Ordinary Meeting of the Council

AGENDA

9.1	Planning Application PLN18/0172 at 454-456 Doncaster Road, Doncaster for the use and development of a three-storey childcare centre plus associated basement and sub-basement car parking, to display a floodlit business identification sign, and alter access to a road in a Road Zone, Category 1	3

9.1 Planning Application PLN18/0172 at 454-456 Doncaster Road, Doncaster for the use and development of a three-storey childcare centre plus associated basement and sub-basement car parking, to display a floodlit business identification sign, and alter access to a road in a Road Zone, Category 1

Figure 9 - Sensitivity plan of Subject Site

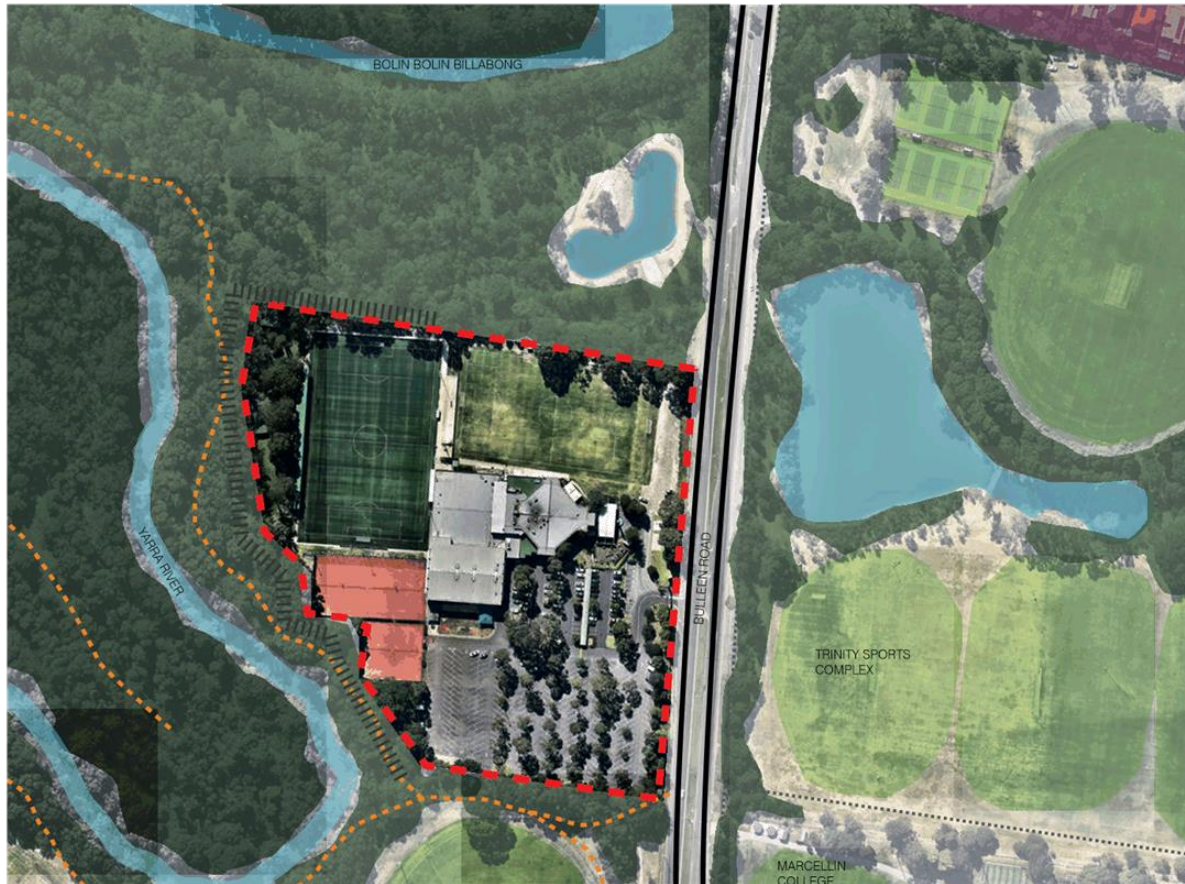
- 2.35 It is also noted that the Veneto Club adjoins the Bolin Bolin Billabong to the north which is a significant and sensitive interface.
- 2.36 The ‘*Sensitivity Plan*’ on p 11 at Figure 9 of the Development Plan does not show the interface of importance extending for the entire northern boundary. It is recommended that this plan be amended to show the interface being extended along this boundary and an additional dot point be included on p11 to acknowledge the proximity to the Bolin Bolin Billabong as a sensitivity associated with the site.

- 2.38.4 The landscape objective under Stage 2 on page 20 stating: "*To ensure new landscaping incorporates native species*": be deleted.
- 2.38.5 Amend the Sensitivity Plan (Figure 9, p11) in the Development Plan to show an extension of the *'Interface of Importance'* along the full extent of the northern boundary of the Veneto Club.
